Modification report to Sydney Central City Planning Panel

Panel reference: PPSSCC-443

MOD number	MOD-22-00316	Date of lodgement	1 August 2022
Applicant	DFP Planning Pty Ltd		
Owner	JLL Development Pty Ltd		
Proposed development	S4.55(2) modification application to increase the overall height and floor area of the building, reduce the number of apartments from 85 to 70, amend the internal layouts of all levels and apartment mix, reduce the rooftop communal open space area, modify the basement car parking levels and reduce number of car spaces from 112 spaces to 103 spaces.		
Street address	55 Newton Road, Blacktown		
Notification period	25 August to 8 September 2022	Number of submissions	0

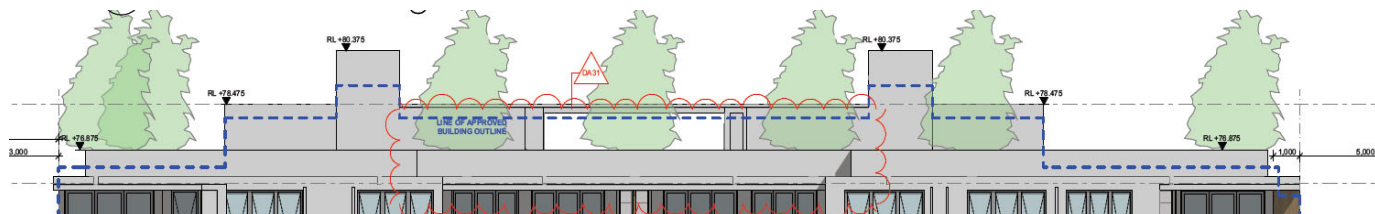
8.1 Proposed increase of the overall building height necessitating variation to the Blacktown Local Environmental Plan 2015 height requirement

- 8.1.2 This proposal seeks to further increase the overall building height by 1.225 m from 22.65 m to 23.875m. The maximum building height under the Blacktown Local Environmental Plan is still 20 m. Therefore, the building height will be further varied by up to a total of 3.875 m representing an increase in the variation from 13.2% to 19.3%, or an additional 6.1% variation. The highest point of the building that will rise will be due to the 2 lift overruns whilst the remainder of the building is only increasing in height slightly by 0.6 m for the top floor (see extract below showing the increase of the building height versus the approved height indicated with blue dashed lines).

- 8.1.3 This increase in the building height is required to meet Building Code of Australia requirements to provide adequate waterproofing and to also meet the minimum floor to ceiling heights of 3.1 m within all the apartments over 6 levels. The modifications have also been made to comply with the requirements for Class 2 buildings under the Design and Building Practitioners Act 2020.

- 8.1.4 Since this is a modification application and a Clause 4.6 variation request was already approved by the Panel under JRPP-16-04457, a further Clause 4.6 variation request is not required. Notwithstanding this, the additional 1.225 m building height is considered negligible given the Panel already approved the building height at over 22 m high.

- 8.1.5 The proposed additional height will have no adverse shadow impact on neighbouring properties and will not result in any residential apartments above the height plane. On this basis this height variation is recommended to be supported.

Rooftop communal open space before

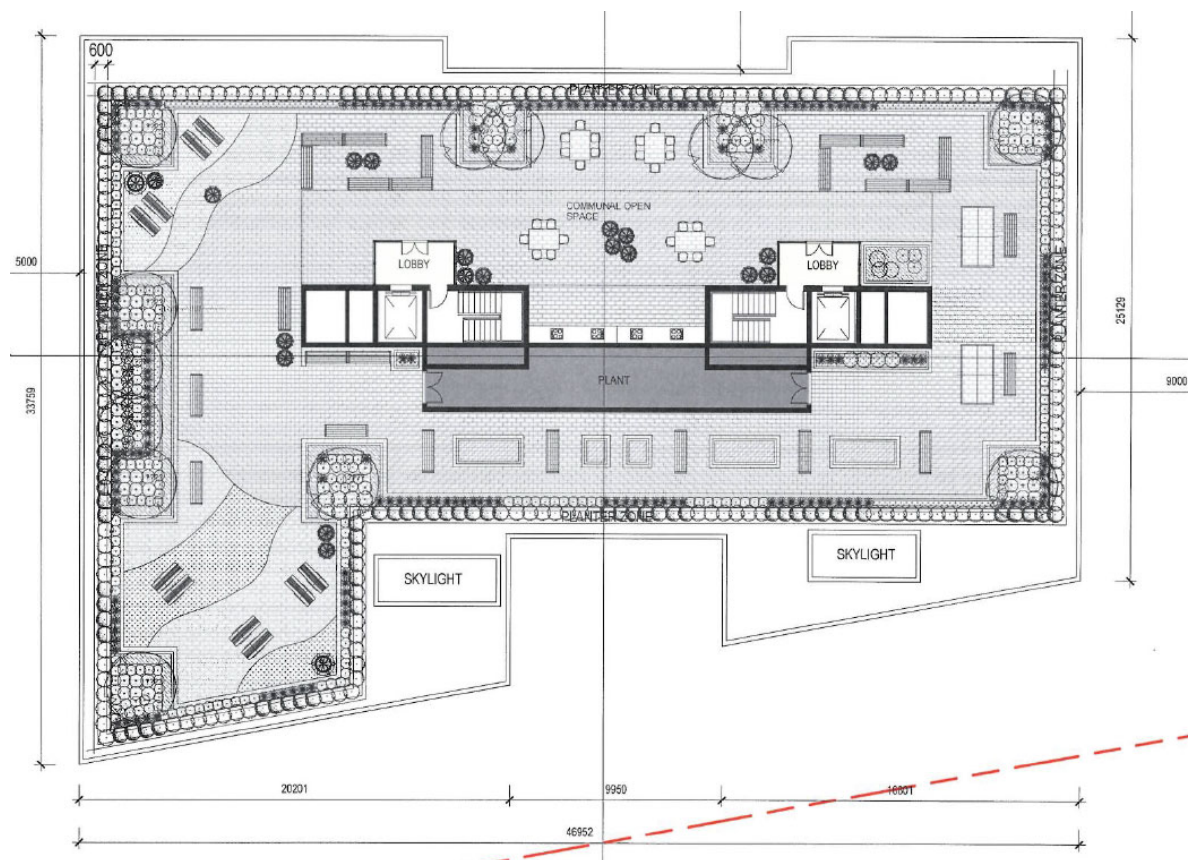
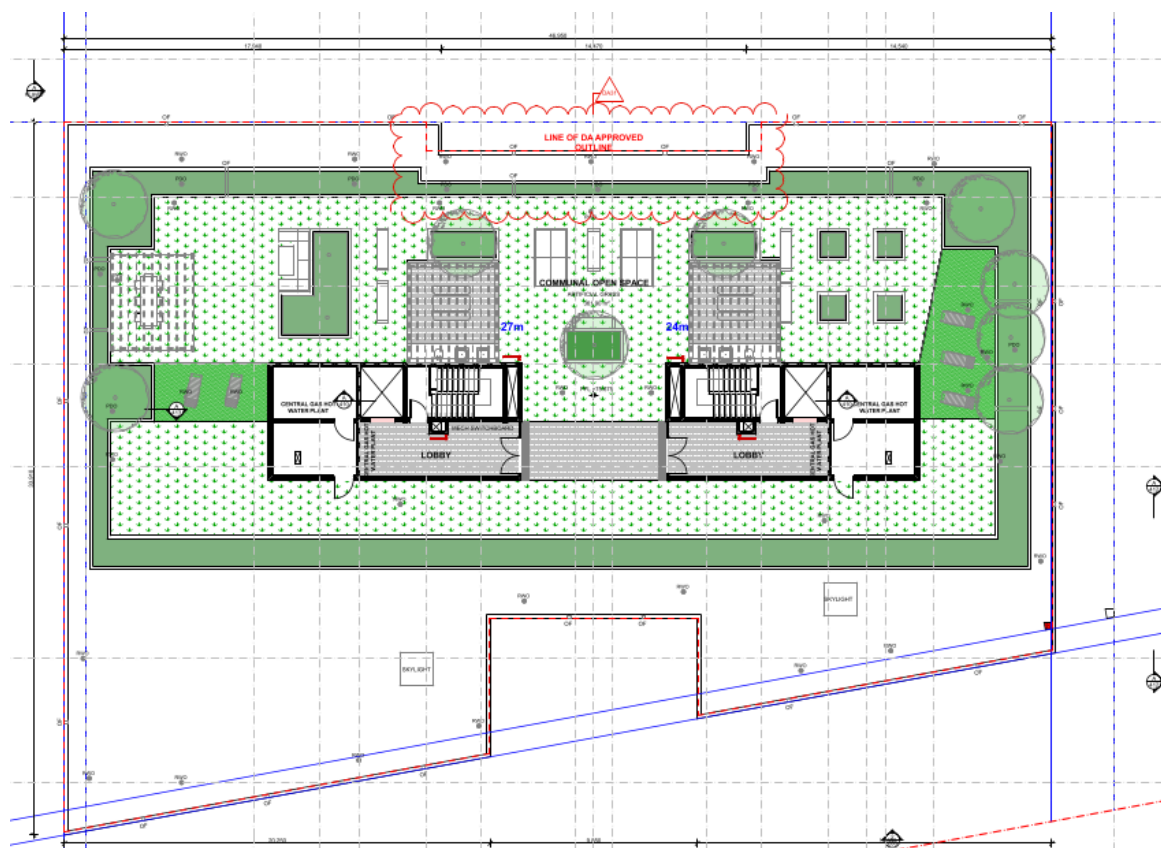
- 8.6.1 The combined communal open space areas are proposed to be reduced by 561.43 m² from 1,428 m² to 866.57 m² or 28.16% of the site area as illustrated below.
- 8.6.2 Part 3D of the Apartment Design Guide prescribes a communal open space area minimum of 25% of the site area. Therefore, the proposed communal open space areas of 28.16% of the site area still exceeds the minimum requirement. As such, a reduction in the combined communal open space areas is considered to be acceptable in the circumstances.

Deep soil zone before

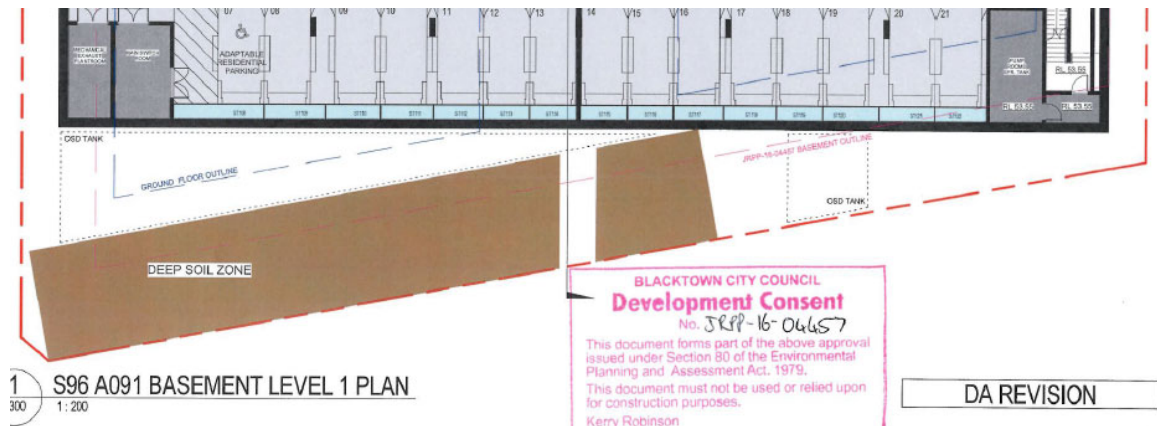
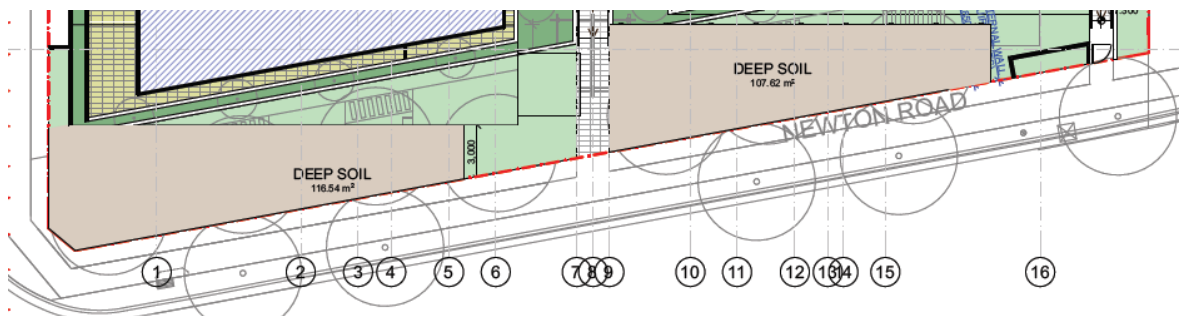
8.7.1 The combined deep soil zones are proposed to be reduced by 14 m² from 238 m² to 224 m² or 7.9% of the site area as illustrated below. This is required to merge the 2 separate on-site detention tanks into 1 tank as well as to provide a location for the construction crane's base.

8.7.2 Part 3E of the Apartment Design Guide prescribes a deep soil zone area minimum of 7% of the site area. Therefore, the proposed reduced deep soil area, being 7.9% of the site area, still complies with the minimum requirement. As such, a reduction in the combined deep soil area is considered to be acceptable in the circumstances.
